Federal Aviation
Administration

Aeronautical Study No.
2018-ANM-720-OE

**** NOTICE OF PRESUMED HAZARD ****

Structure:	LNG Carrier Vessel - Stack, Transit Point 6
Location:	North Bend, OR
Latitude:	43-25-13.85N NAD 83
Longitude:	124-16-09.31W
Heights:	12 feet site elevation (SE) 199 feet above ground level (AGL) 211 feet above mean sea level (AMSL)

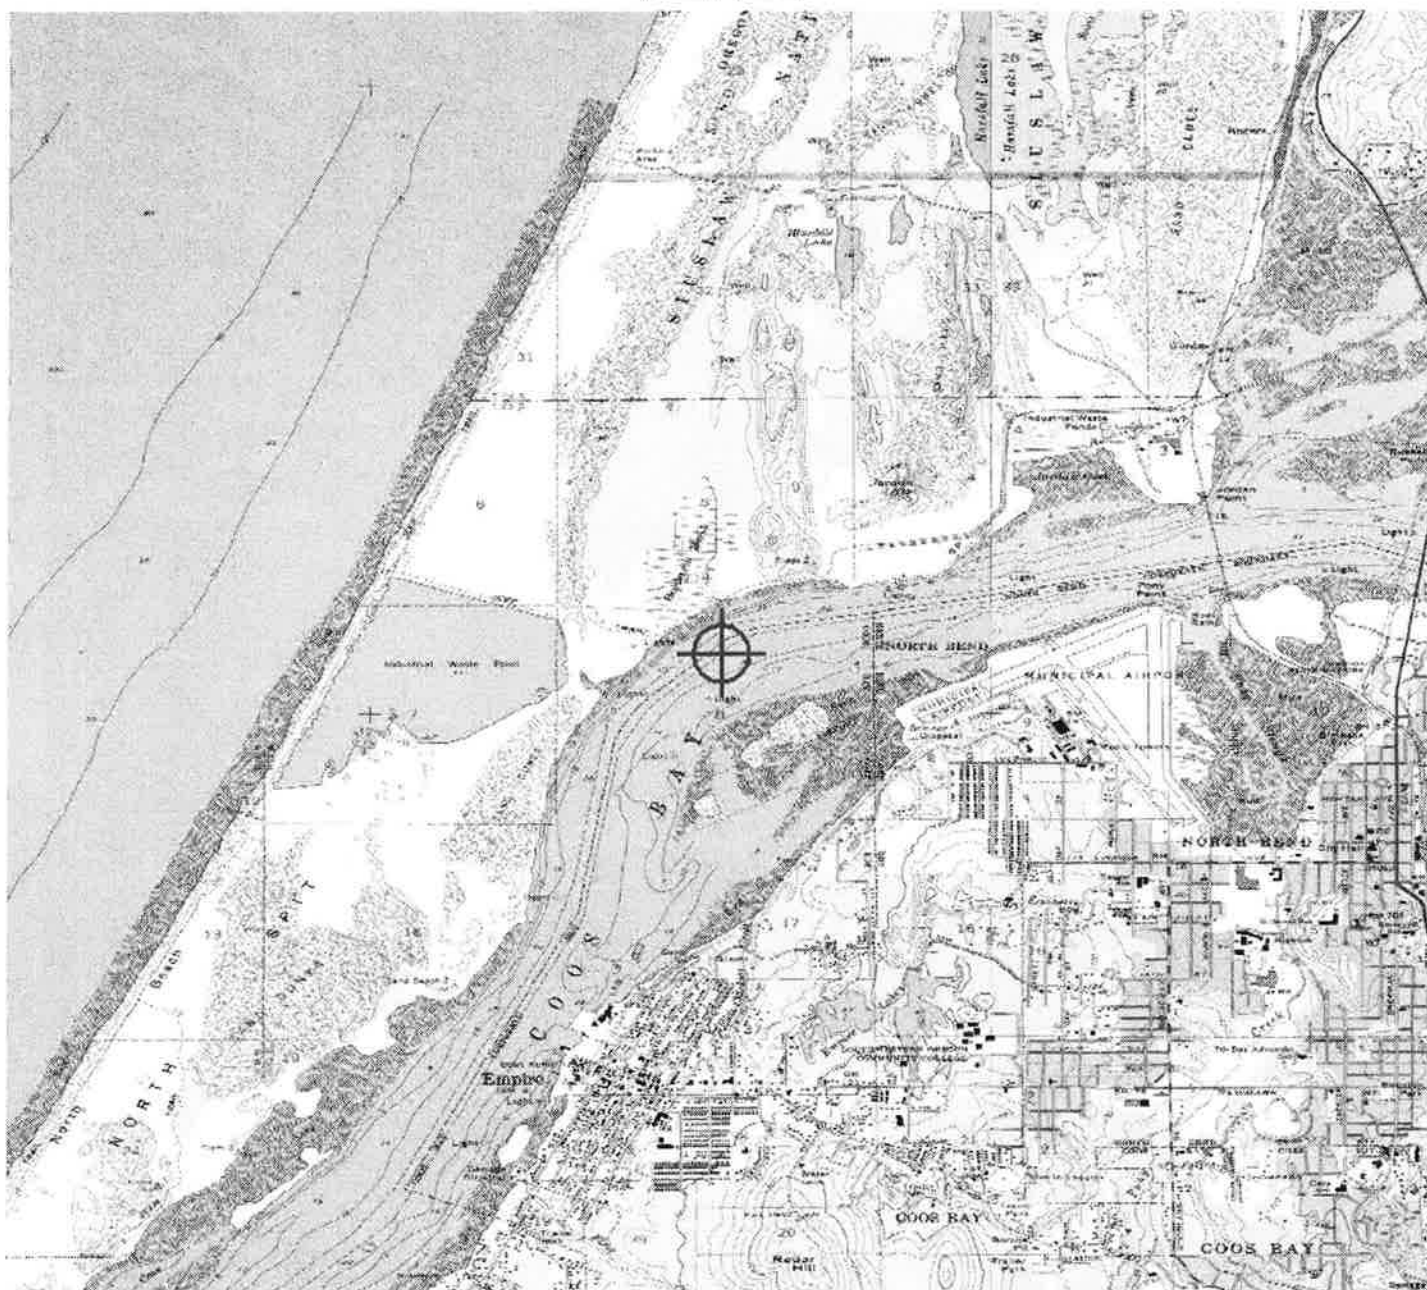
Our aeronautical study has disclosed that the proposed 199-foot AGL (211-foot AMSL) liquid natural gas carrier vessel (ship stack) shipping channel transit point location associated with the proposed Jordan Cove Liquid Natural Gas Terminal penetrates 14 CFR Part 77 protected airspace surfaces at Southwest Oregon Regional Airport (OTH) in North Bend, OR. The OTH airport elevation is 17 feet AMSL.

Section 77.19(a): Horizontal Surface-a height exceeding a horizontal plane 150 feet above the established airport elevation. The proposed structure would exceed the OTH Horizontal Surface by 44 feet.

Additionally, the proposed structure would exceed the OTH VFR traffic pattern airspace in the Part 77 VFR Horizontal Surface feet as defined in FAA JO 7400.2L, 6-3-8, Evaluating Effect on VFR Operations.

This proposed structure would exceed the OTH VFR Traffic Pattern Horizontal Surface by 44 feet. The not-to-exceed height of 155 feet AGL (167 AMSL) will avoid penetrating the Horizontal Surface.

1. You must resolve the 44 foot VFR Traffic Pattern Airspace penetration by lowering the structure height, with all appurtenances, to a maximum height at 155 feet AGL (167 AMSL). If you agree to limit the structure height to 155 feet AGL (167 AMSL), the FAA can then withdraw this objection to the proposed structure as it would not exceed obstruction standards and a favorable determination could be subsequently issued.
2. You can terminate the proposal at this location.

Aeronautical Study No.
2018-ANM-718-OE

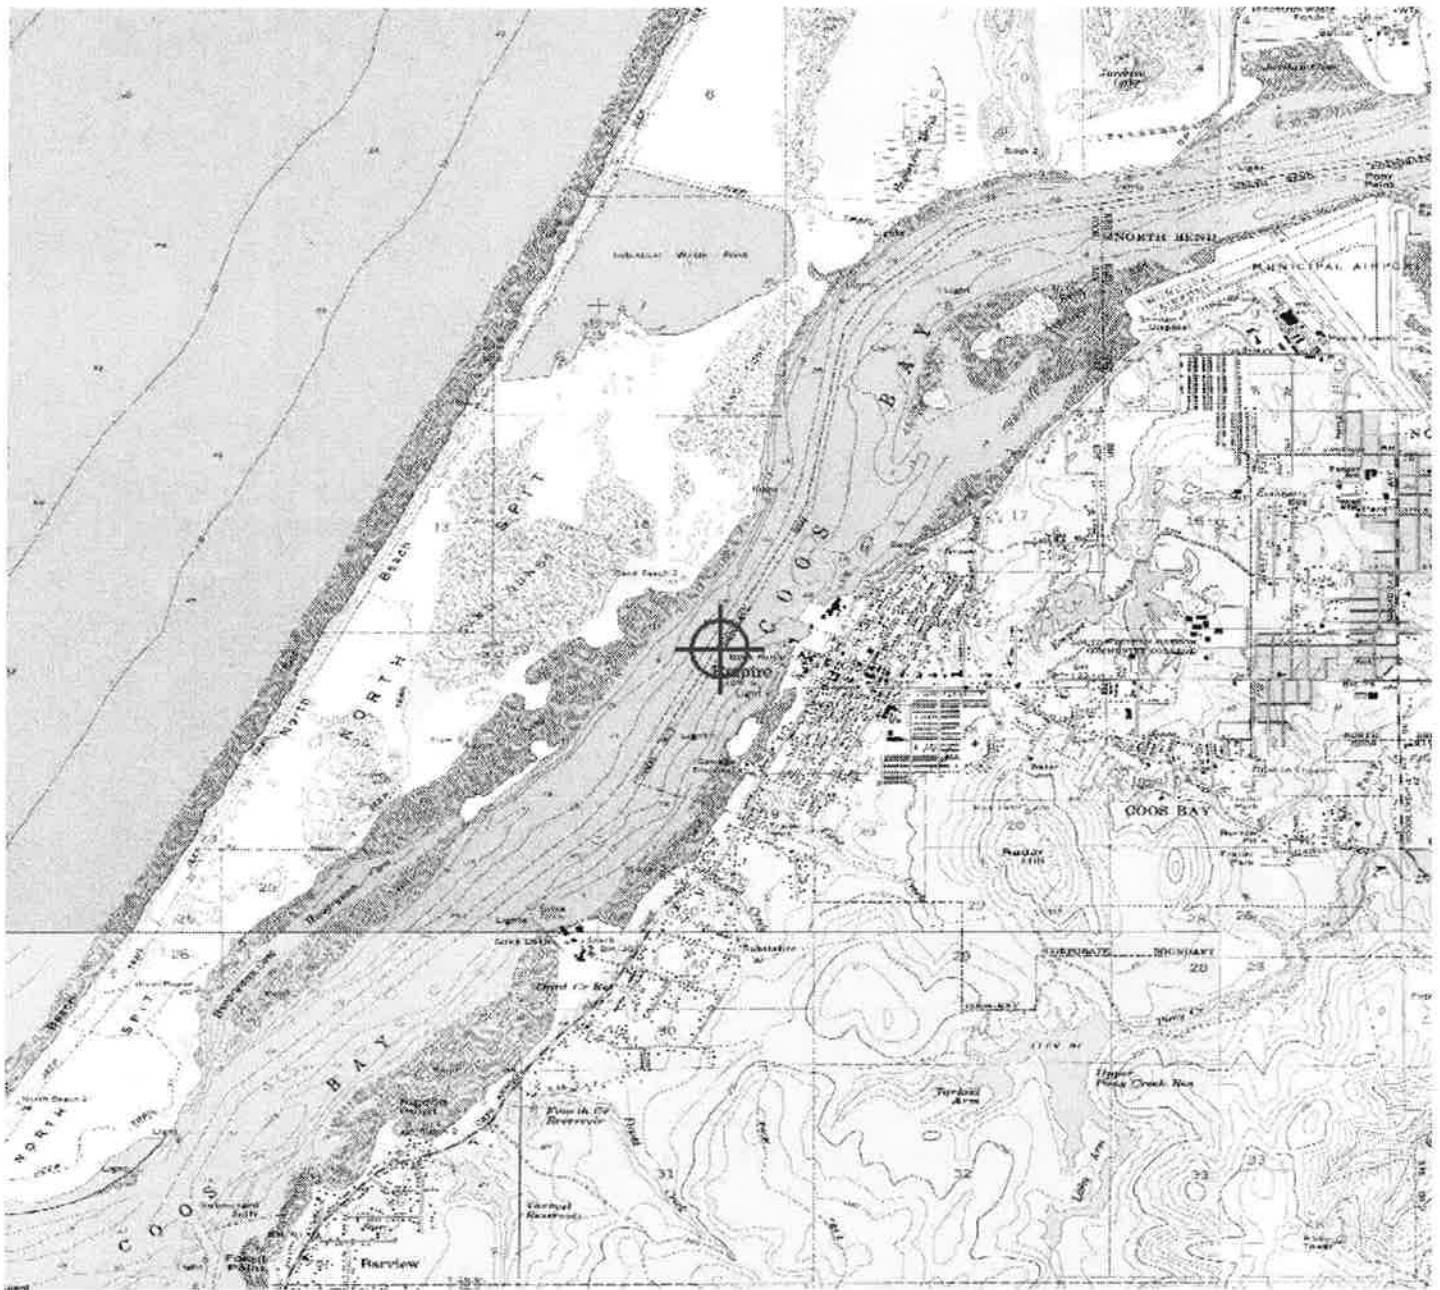
Our aeronautical study has disclosed that the proposed 199-foot AGL (211-foot AMSL) liquid natural gas carrier vessel (ship stack) shipping channel transit point location associated with the proposed Jordan Cove Liquid Natural Gas Terminal penetrates 14 CFR Part 77 protected airspace surfaces at Southwest Oregon Regional Airport (OTH) in North Bend, OR. The OTH airport elevation is 17 feet AMSL.

Section 77.19(a): Horizontal Surface-a height exceeding a horizontal plane 150 feet above the established airport elevation. The proposed structure would exceed the OTH Horizontal Surface by 44 feet.

1. If you agree to limit the structure height to 155 feet AGL (167 AMSL), the FAA can then withdraw this objection to the proposed structure as it would not exceed obstruction standards and a favorable determination could be subsequently issued.
2. You can terminate the proposal at this location.
3. You can request further FAA study of the structure at the originally requested height. Further study will include a public notice circularization and 37-day comment period where the outcome cannot be predicted.

Aeronautical Study No.
2018-ANM-8-OE

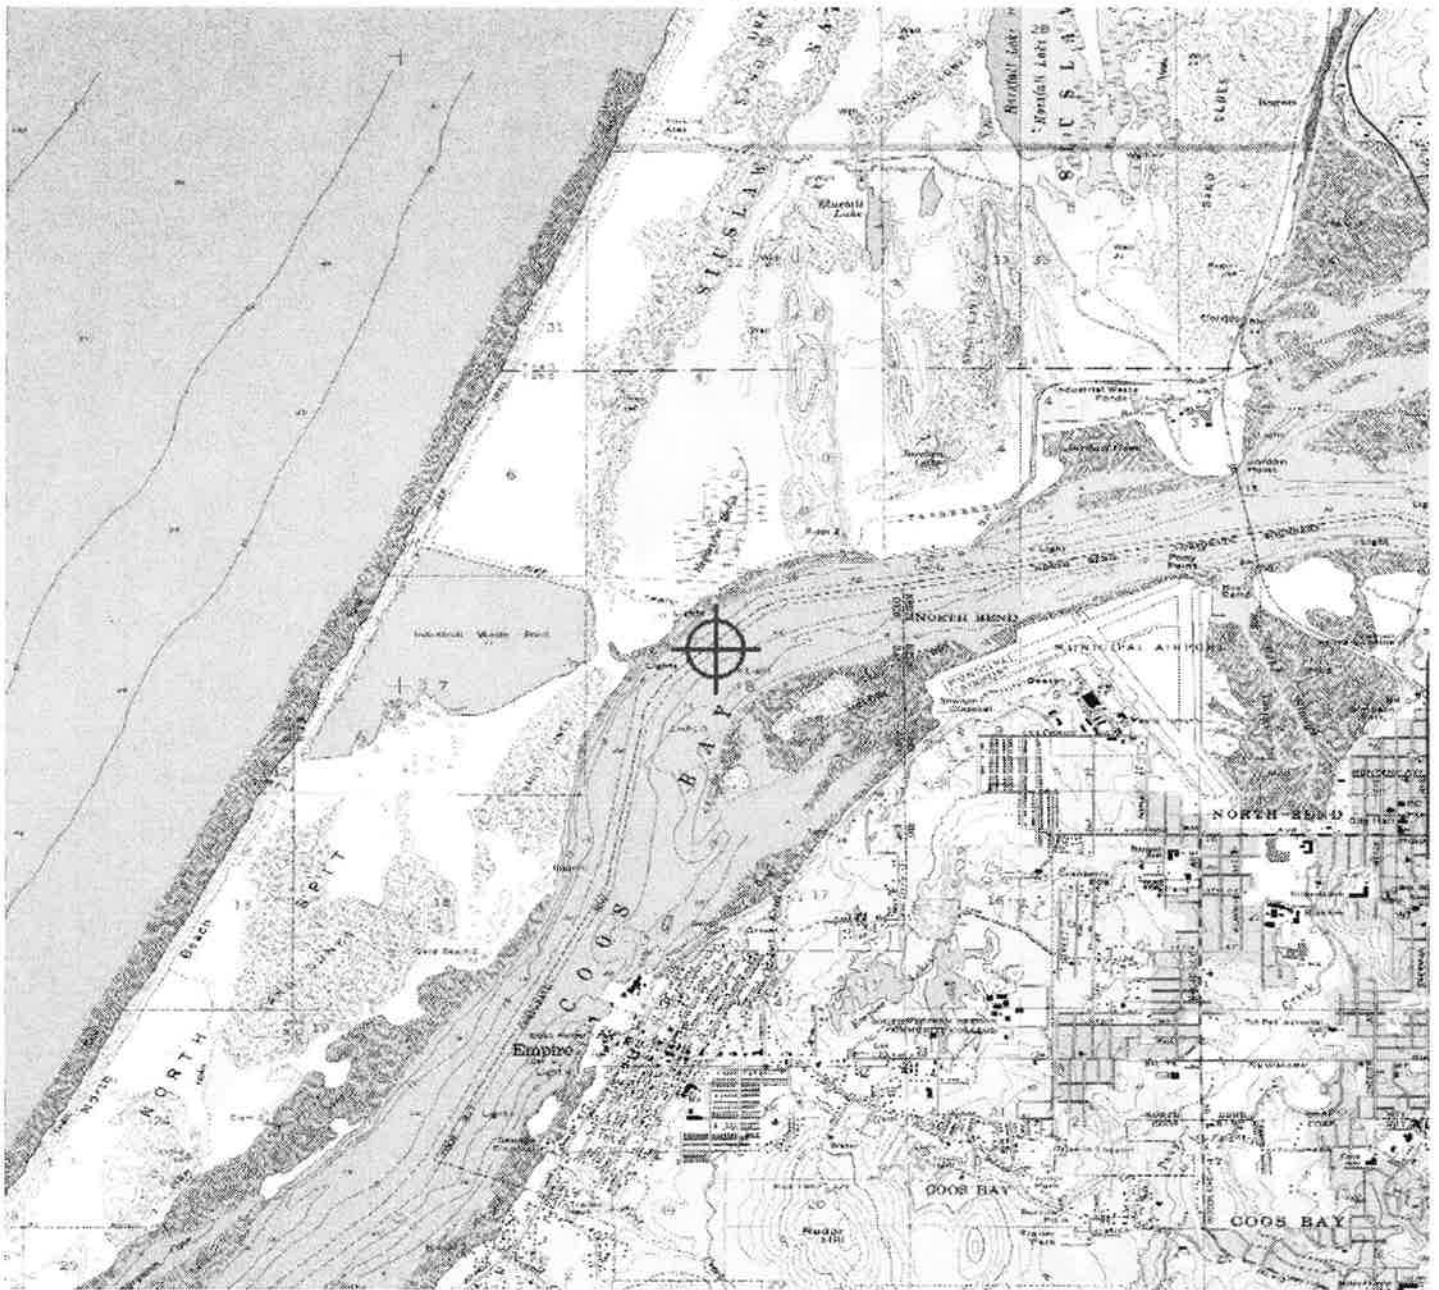
Our aeronautical study has disclosed that the proposed 199-foot AGL (211-foot AMSL) liquid natural gas carrier vessel (ship stack) shipping channel transit point location associated with the proposed Jordan Cove Liquid Natural Gas Terminal penetrates 14 CFR Part 77 protected airspace surfaces at Southwest Oregon Regional Airport (OTH) in North Bend, OR. The OTH airport elevation is 17 feet AMSL.

Section 77.19(a): Horizontal Surface-a height exceeding a horizontal plane 150 feet above the established airport elevation. The proposed structure would exceed the OTH Horizontal Surface by 44 feet.

Additionally, the proposed structure would exceed the OTH VFR traffic pattern airspace in the Part 77 VFR Horizontal Surface feet as defined in FAA JO 7400.2L, 6-3-8, Evaluating Effect on VFR Operations.

This proposed structure would exceed the OTH VFR Traffic Pattern Horizontal Surface by 44 feet. The not-to-exceed height of 155 feet AGL (167 AMSL) will avoid penetrating the Horizontal Surface.

1. You must resolve the 44 foot VFR Traffic Pattern Airspace penetration by lowering the structure height, with all appurtenances, to a maximum height at 155 feet AGL (167 AMSL). If you agree to limit the structure height to 155 feet AGL (167 AMSL), the FAA can then withdraw this objection to the proposed structure as it would not exceed obstruction standards and a favorable determination could be subsequently issued. Further FAA study for any height greater than 155 AGL / 167 AMSL is not an option.
2. You can terminate the proposal at this location.

Aeronautical Study No.
2018-ANM-6-OE

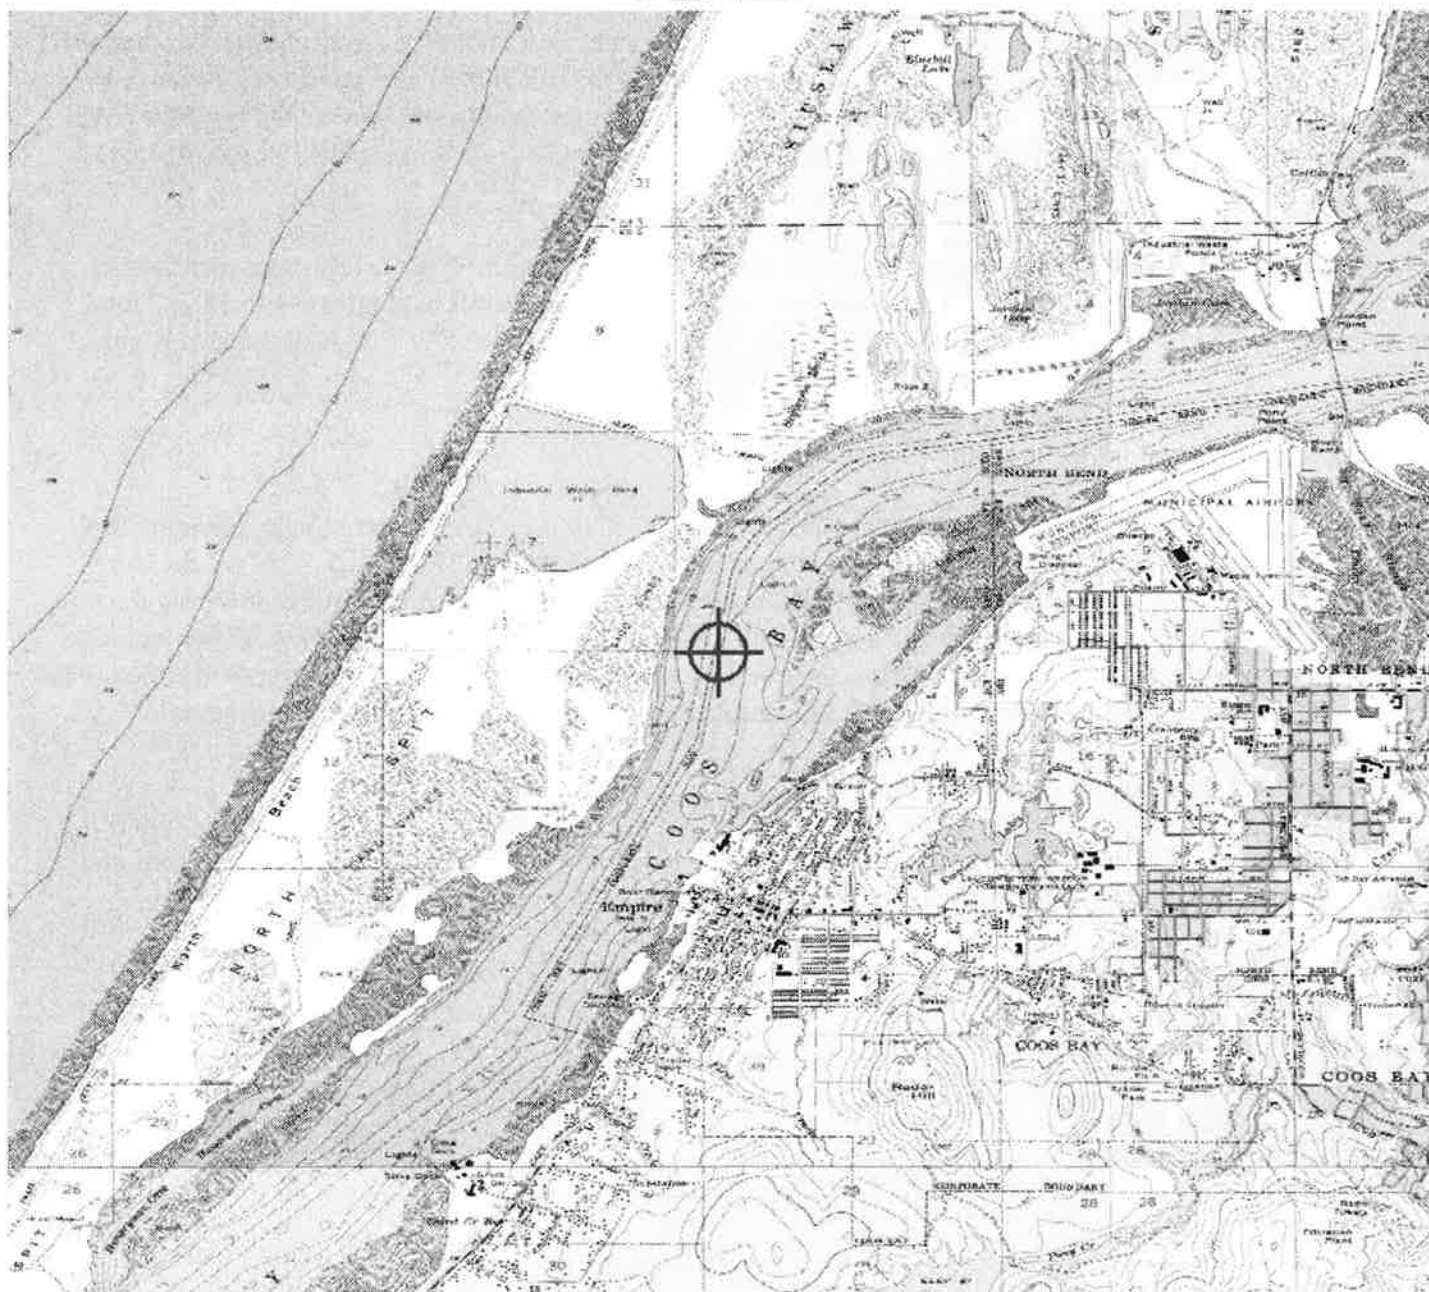
- a. Section 77.17(a)(3) -- A structure that causes less than the required obstacle clearance within a terminal obstacle clearance area, including an initial approach segment, a departure area, and a circling approach area resulting in increases to an IFR terminal minimum altitude. The high point on the LNG carrier vessel (stack) would have the following effects on IFR operations at OTH:

Obstacle penetrates OTH RWY 22 40:1 departure surface in the Initial Climb Area (ICA) 73 feet, increases climb gradient from standard and 200 feet per NM to 300-1 or standard with 423 feet per NM to 400 then as published. The height at or below that avoids this effect: 138 AMSL (126 AGL).

b. Section 77.19(a): Horizontal Surface-a height exceeding a horizontal plane 150 feet above the established airport elevation. The proposed structure would exceed the OTH Horizontal Surface by 44 feet.

c. Section 77.19(d) -- Approach Surface - an area designated to protect aircraft during the final approach phase of flight at an airport: The proposed structure would exceed the existing OTH Approach Surface by 102 feet and would exceed the OTH Approach Surface plan on file by 122 feet.

Additionally, the proposed structure would exceed the OTH VFR traffic pattern airspace in the Part 77 VFR Horizontal Surface and the Approach Surface (plan on file) as defined in FAA JO 7400.2L, 6-3-8, Evaluating Effect on VFR Operations.

structure would exceed the OTH VFR Traffic Pattern Approach Surface (plan on file) by 11 feet. The not-to-exceed height of 188 feet AGL (200 AMSL) will avoid penetrating the Approach Surface (plan on file).

The FAA Technical Operations Branch found the proposal has a physical and/or an electromagnetic radiation effect upon the Visual Approach Slope Indicator (VASI) serving OTH RWY 04 as it penetrates the surface given in the siting standard, Order 6850.2. The proposal will affect the quality and/or availability of the VASI visual guidance signal (service). The effect can be eliminated by lowering the proposal to 145 ft AMSL (132 AGL).

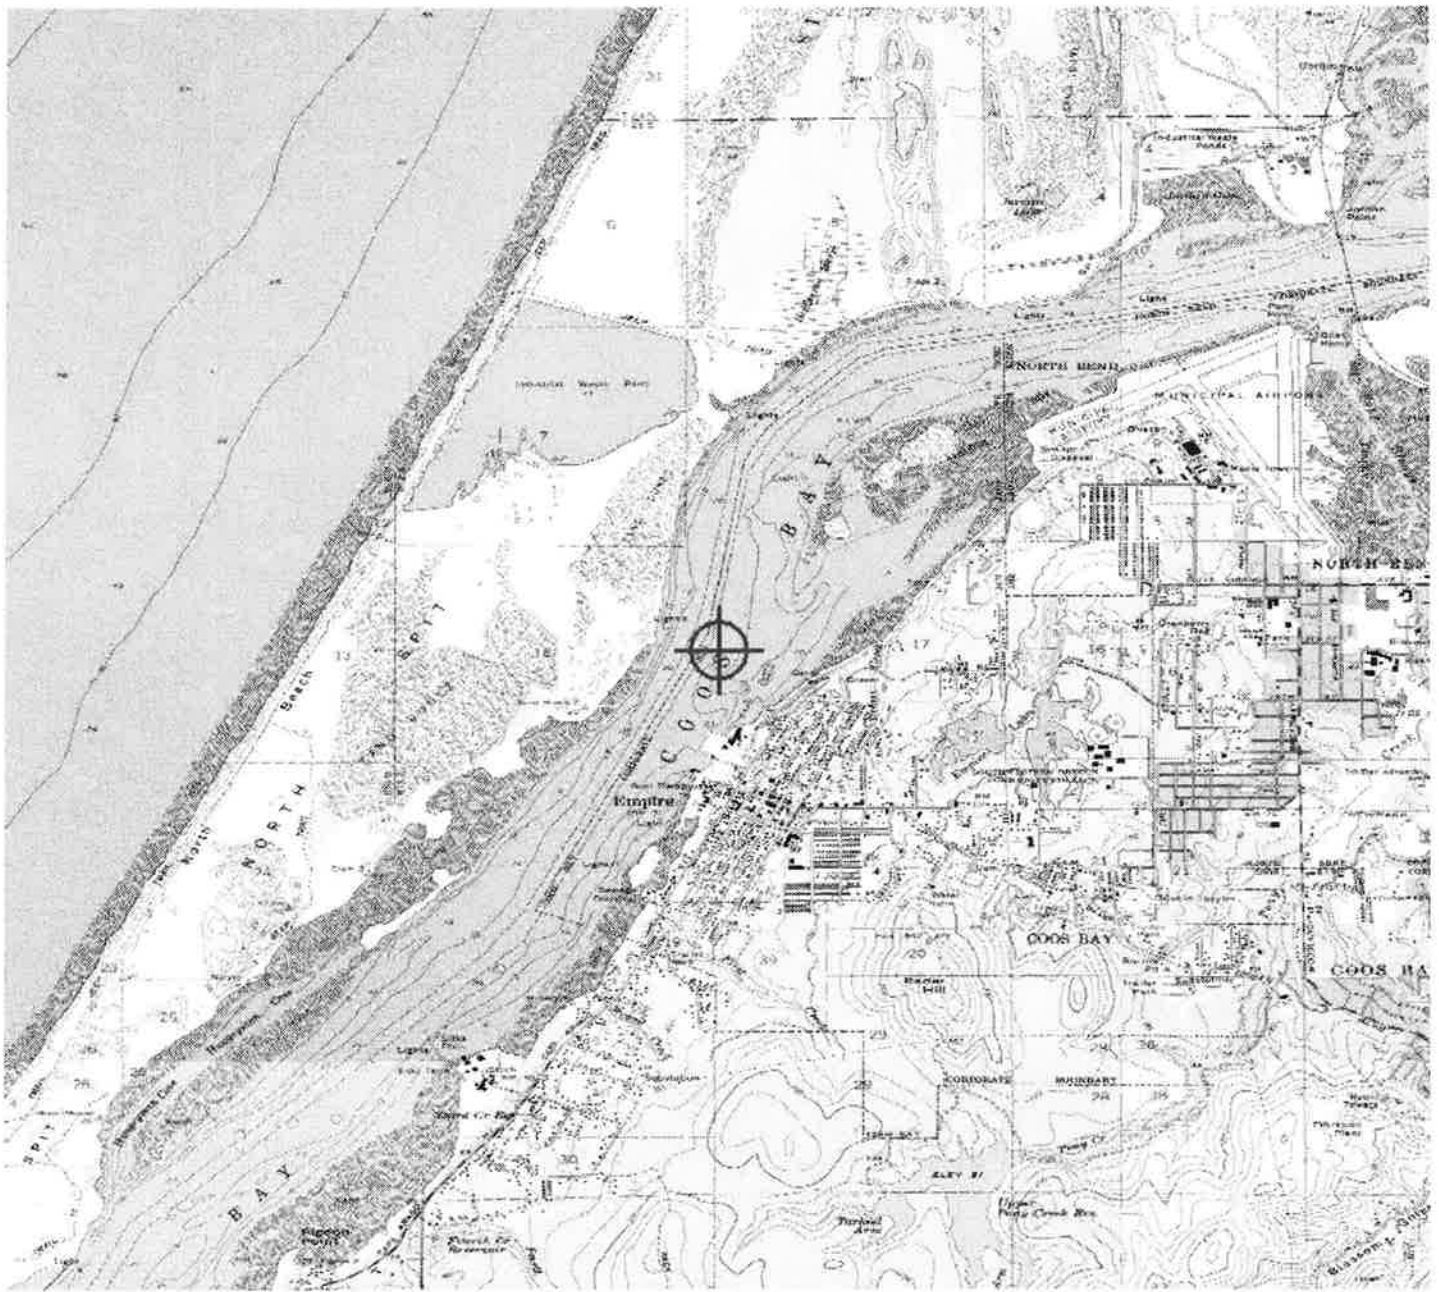
b. Section 77.19(a): Horizontal Surface-a height exceeding a horizontal plane 150 feet above the established airport elevation. The proposed structure would exceed the OTH Horizontal Surface by 44 feet.

Surface is defined in Part 77 Section 77.19(b) as a surface extending outward and upward from the periphery of the VFR Part 77 Horizontal Surface at a slope of 20:1 for a horizontal distance of 4,000 feet .

This proposed structure would exceed the OTH VFR Traffic Pattern Conical Surface by 25 feet. The not-to-exceed height of 186 feet AGL (198 AMSL) will avoid penetrating the Conical Surface.

The FAA Technical Operations Branch found that while the proposal is laterally beyond the standard 10° visual slope approach indicator (VASI) obstacle clearance surface (OCS), however, it is within 15° of the extended runway centerline and above the VASI OCS. The proposal may be within the lateral limits of the visible light beam of the VASI serving OTH RWY 04. The height at or below that avoids this effect is 187 AMSL
